**Attachment A - Table identifying the Department's email dated 13 February 2024**

**Attachment B - Table identifying the Department's Request for Additional Information dated 15 September 2023, the applicant's information emailed to the Department on 16 May 2023, and the Department's comments**

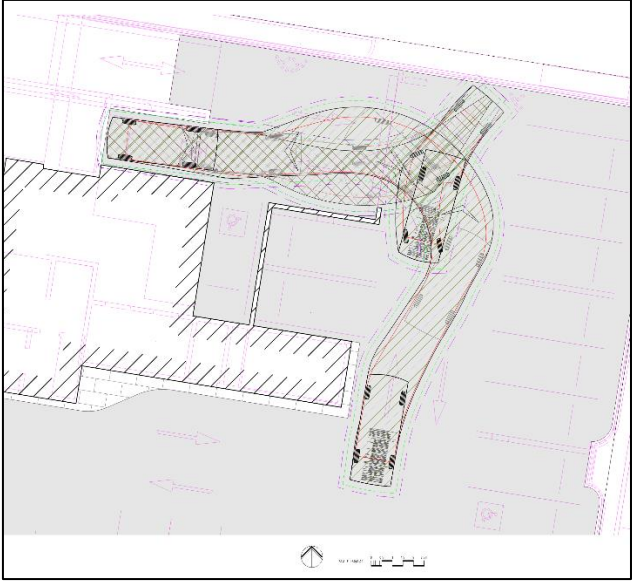
<b>2.1.2</b>	<ul style="list-style-type: none"> <li>addresses Council's comment that during the 1%AEP local catchment event there are flood impacts of greater than 100mm onto the neighbouring property resulting from this development and that there are flood impacts of up to 75mm during the 1%AEP Narara Creek event.</li> </ul>	<p>Updated flood modelling has been prepared herein. Flood effects have been reduced to be generally less than 20mm in the northern carpark at 1 Racecourse Road during the Local Catchment 1% AEP design storm event. No impact on existing Flood Planning Levels or hazard conditions are expected due to the increase.</p> <p>As such, the increase is not expected to create a significant adverse impact to the existing flood behaviour within this property.</p> <p>Please refer to the Flood Effects section of this report for further details.</p>	<p>Figure D2 in Appendix C maps that there is &gt;10mm increase at the southwest of the subject site, but no affect immediately adjacent at neighbouring property 61 Central Coast Hwy. Please clarify whether there is a fence or other boundary obstruction existing, assumed or proposed.</p> <p>The Department notes that Appendix D figures show a climate change scenario, and there are increases to flood depth to the northern and southern adjoining properties and Racecourse Road.</p>	<p>The full and comprehensive package submitted for final determination on 13 December 2024 includes a fully updated Flood Assessment Report under <b>Appendix 18</b>.</p> <p>Of note are the following:</p> <ul style="list-style-type: none"> <li>Figure D2 at Appendix C generally shows a reduction in flood level offsite.</li> <li>Figure D2 shows a depth difference as a result of the design levels having been lowered along the south-western extent, which means the flood depth has been increased. As there is no increase in flood level at the adjacent property, there is no increase in flood depth.</li> <li>Floor levels are provided above the FPL. No sensitive goods would be stored below this level. The storage of sensitive/ perishable goods would ultimately be at the occupant's discretion, noting the extremely unlikely occurrence of a flood event exceeding the FFL.</li> <li>The building is to be designed to withstand forces from the PMF. It is noted that the flood depth and velocities will be higher in surrounding areas, with external vehicles</li> </ul>

<p>and debris posing a more significant risk. The extremely unlikely occurrence of such a flood event should also be considered.</p> <ul style="list-style-type: none"> <li>This increase does not impact the hazard category of the adjacent site, nor does it flood an area that was previously flooded. It does not pose any increased risk to an existing development or property. Should any future development occur on the site, then the minor increase would not impact the required floor levels or the use of the lot.</li> <li>In summary, this very minor increase does not change the flood risk or extent of the property, and is considered insignificant when considering the flood controls of the adjacent property.</li> </ul>
